APPLICATION NO.	FILING DATE	FIRST NAMED INVENTOR	ATTORNEY DOCKET NO.	CONFIRMATION NO.
10/580,211	05/23/2006	Yoshiki Tsuchiyama	1919.1009	1850
21171 STAAS & HAL	7590 03/25/200 SEY LLP	EXAMINER		
SUITE 700		SEVERSON, JEREMY R		
1201 NEW YORK AVENUE, N.W. WASHINGTON, DC 20005			ART UNIT	PAPER NUMBER
			3653	
			MAIL DATE	DELIVERY MODE
			03/25/2008	PAPER

Application No.	Applicant(s)			
	10/580,211	TSUCHIYAMA ET AL.			
Office Action Summary	Examiner	Art Unit			
	JEREMY R. SEVERSON	3653			
The MAILING DATE of this communication app Period for Reply	ears on the cover sheet with the c	orrespondence address			
A SHORTENED STATUTORY PERIOD FOR REPLY WHICHEVER IS LONGER, FROM THE MAILING DA  - Extensions of time may be available under the provisions of 37 CFR 1.13 after SIX (6) MONTHS from the mailing date of this communication.  - If NO period for reply is specified above, the maximum statutory period w  - Failure to reply within the set or extended period for reply will, by statute, Any reply received by the Office later than three months after the mailing earned patent term adjustment. See 37 CFR 1.704(b).	ATE OF THIS COMMUNICATION 36(a). In no event, however, may a reply be tim vill app

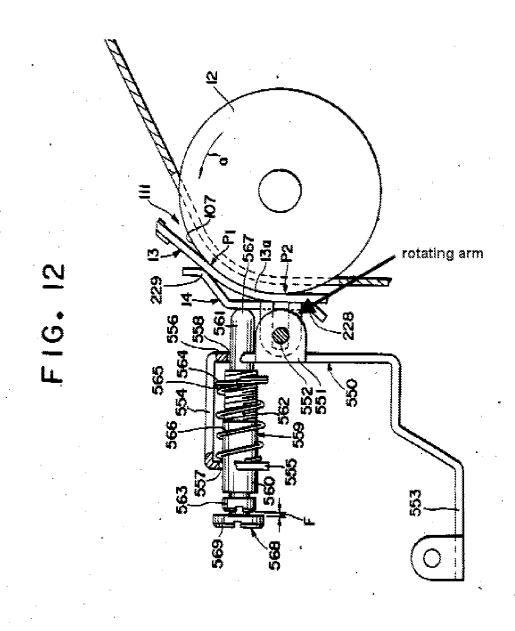
Re claim 1, Murayoshi discloses an automatic paper feeder supplying paper to an apparatus such as a printer or a scanner, comprising: a separation pad 13, pressing the paper against a pick roller 12 so as to feed the paper one by one; and pad pressing means 14, applying pressure to the separation pad so as to press the separation pad against a surface of the pick roller, wherein the pad pressing means is formed in a

reverse U-shape so that the separation pad is arranged such as to be pressed at two front and rear portions thereof against the surface of the pick roller, and wherein the pad pressing means is structured to be rotatable back and forth with respect to a rotating direction of the pick roller about a fulcrum 552 where pressure is applied to the pad pressing means. See fig. 12 and col. 17, lines 63 et seq.

Re claim 3, Murayoshi discloses the automatic paper feeder according to claim 1 or 2, wherein the fulcrum where the pressure is applied to the pad pressing means is arranged such as to be movable back and forth depending on a type of paper which is fed. The movement of bracket 550 causes movement of fulcrum 552. See col. 18, lines 3-7.
